# CITY OF ALBUQUERQUE

**Re: Marble Brewery-New Building Addition**  
**111 Marble Ave NW**  
**Request Temporary 90-day C.O. - Accepted**  
**Engineer's Stamp dated: 9-1-15 (J14D140)**  
**Certification dated: 2-4-16**

## MARBLE BREWERY NEW BUILDING ADDITION

1.	09/1/2015	Rev. Tanks and Update Pond
MARK	DATE	DESCRIPTION
ISSUE:		DRB AA 2014
PROJECT NO:		1407
CAD DWG FILE:		
DRAWN BY:		
CHECKED BY:		
DATE:		8/25/14
SHEET TITLE		
GRADING & DRAINAGE PLAN

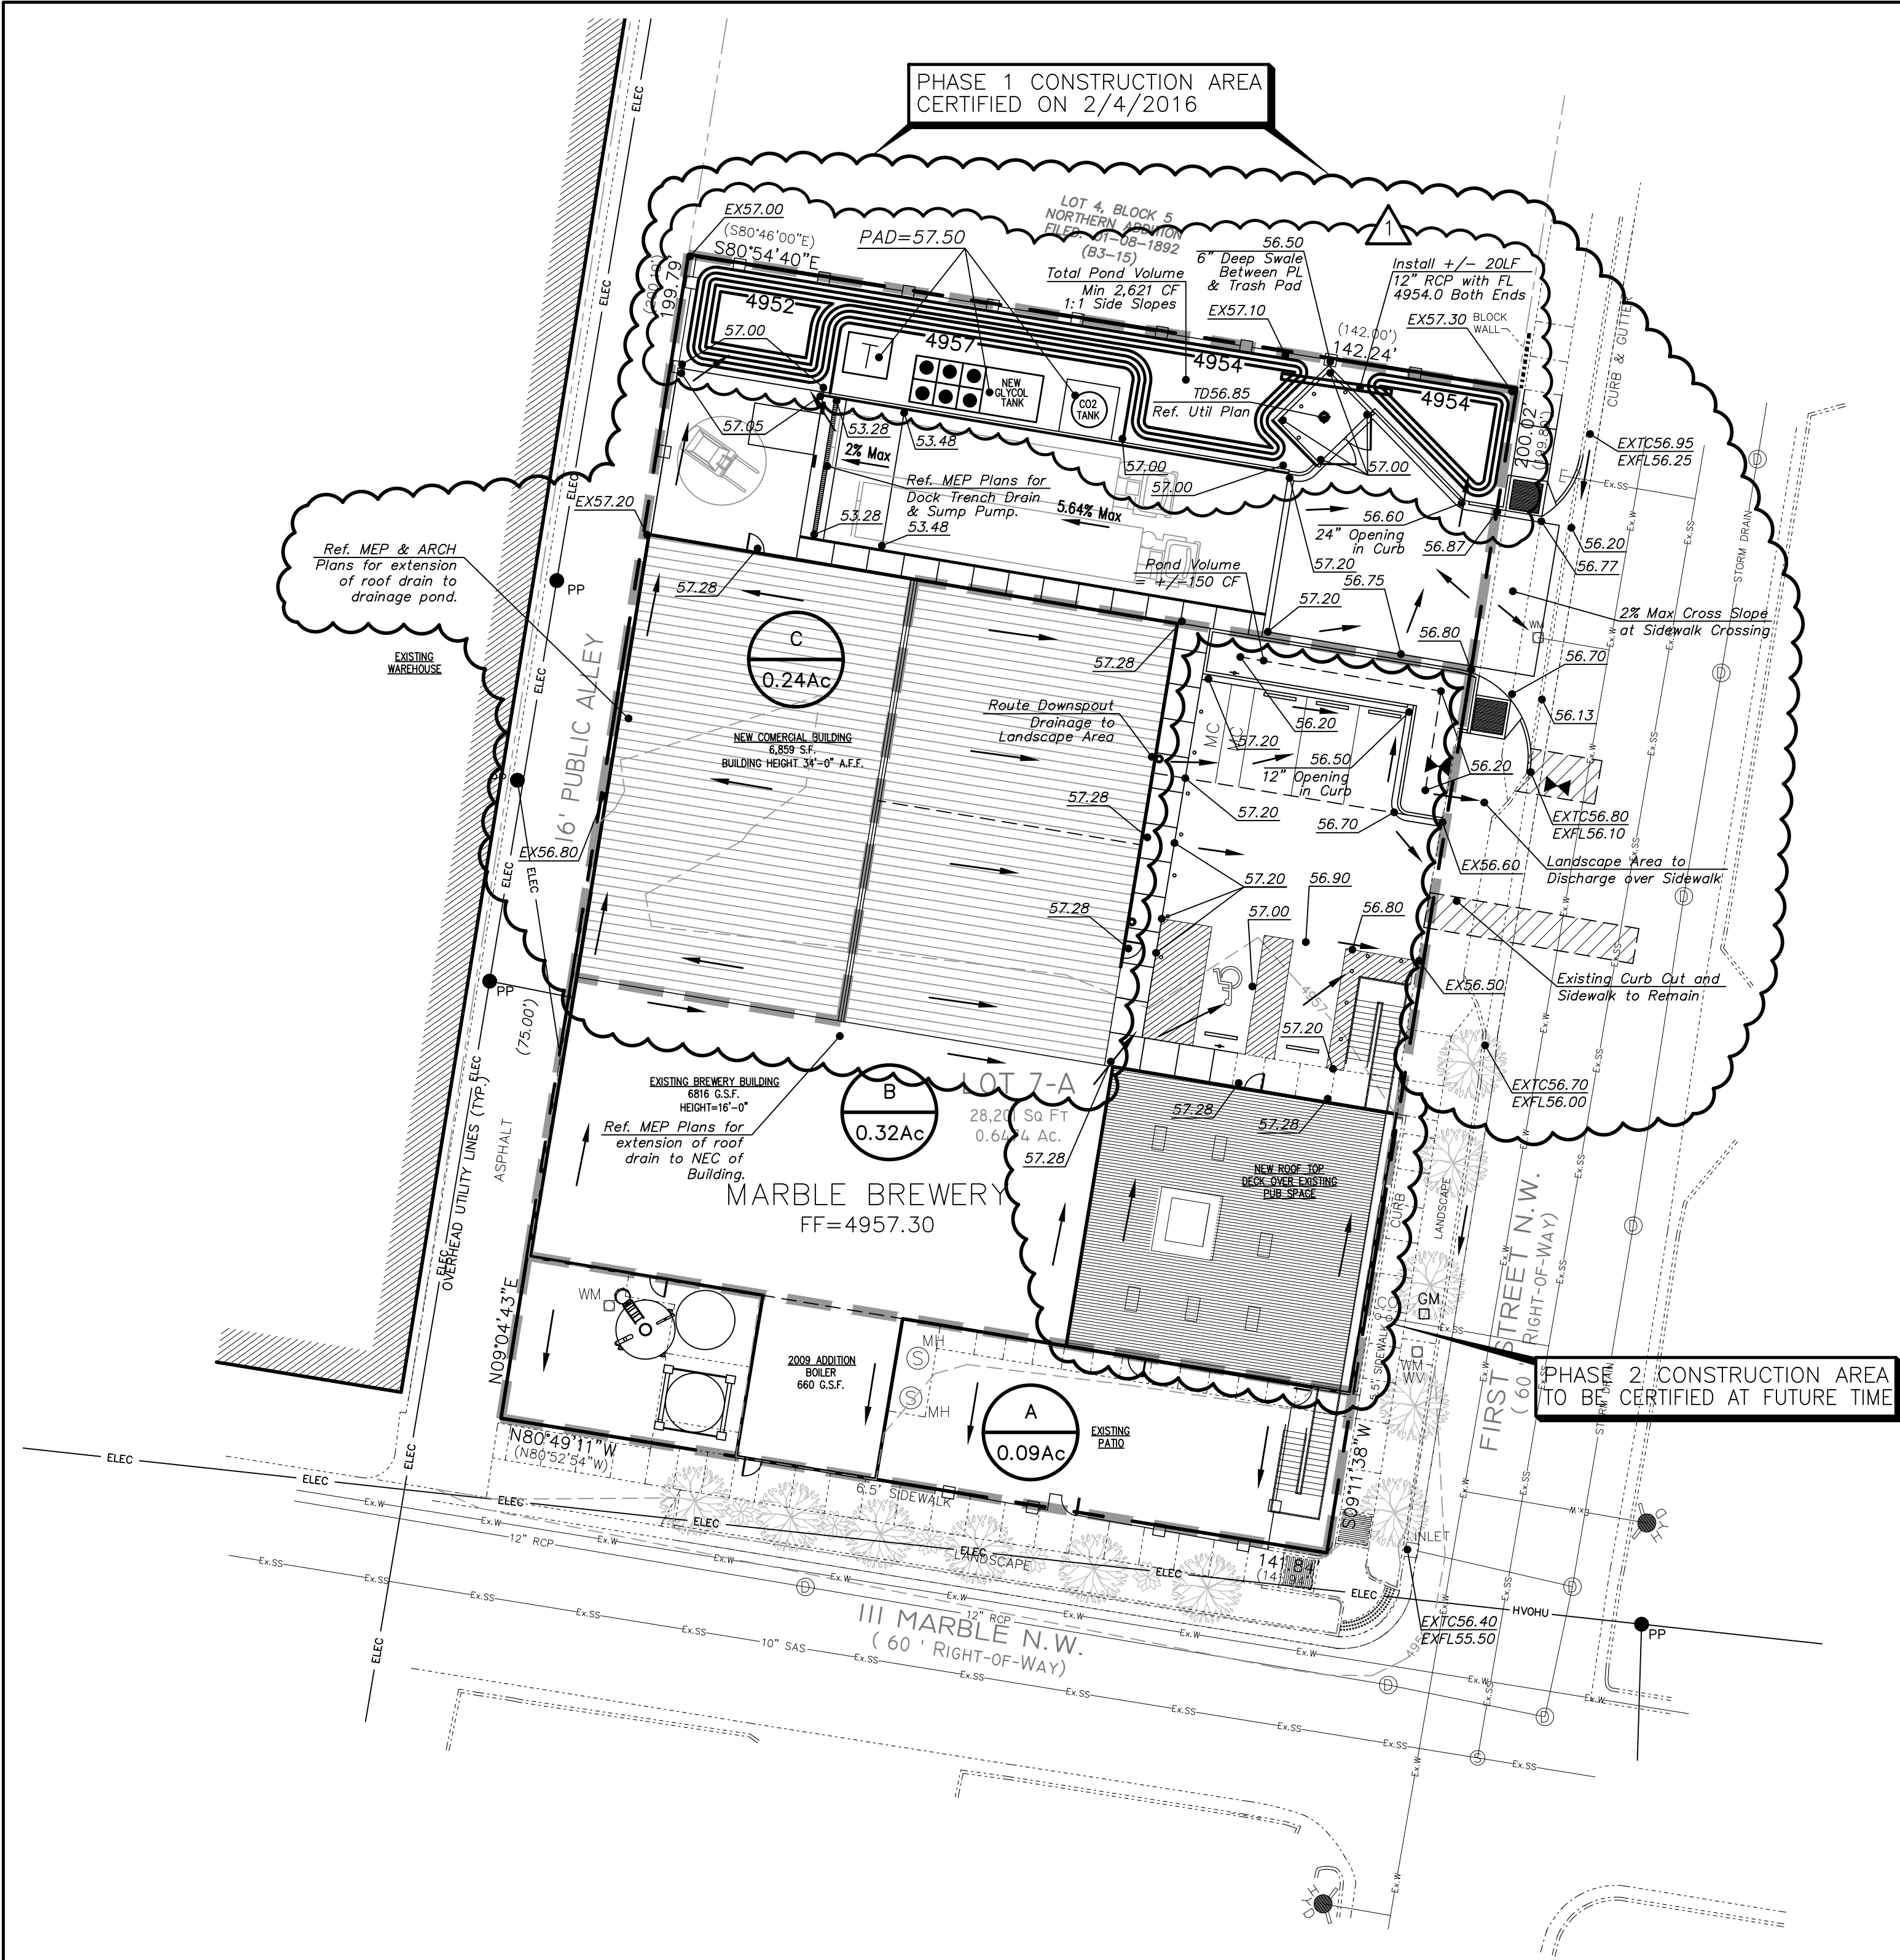
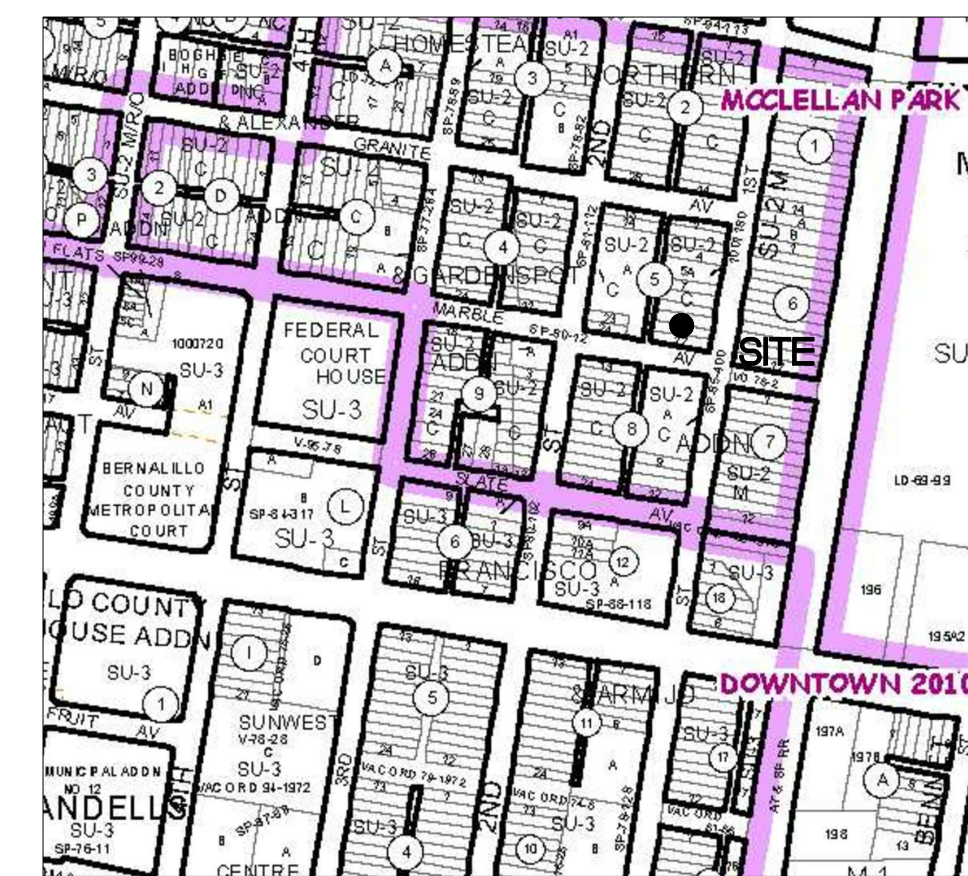
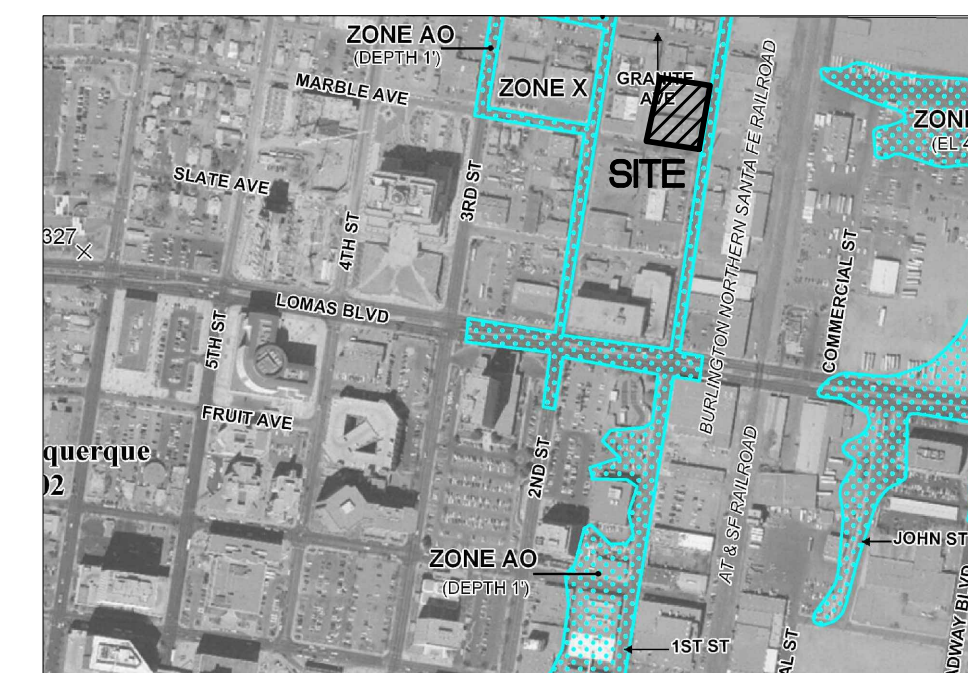
Based on the certification provided in your submittal received 2/3/2016, the above referenced is approved for a 90-day Temporary Release of Occupancy by Hydrology. However, before a permanent CO can be accepted the following comments must be addressed.

- Call out on as-built change in the dock trench drain.
- Complete construction of parking lot.

An inspection by our office will need to take place after these corrects are made.
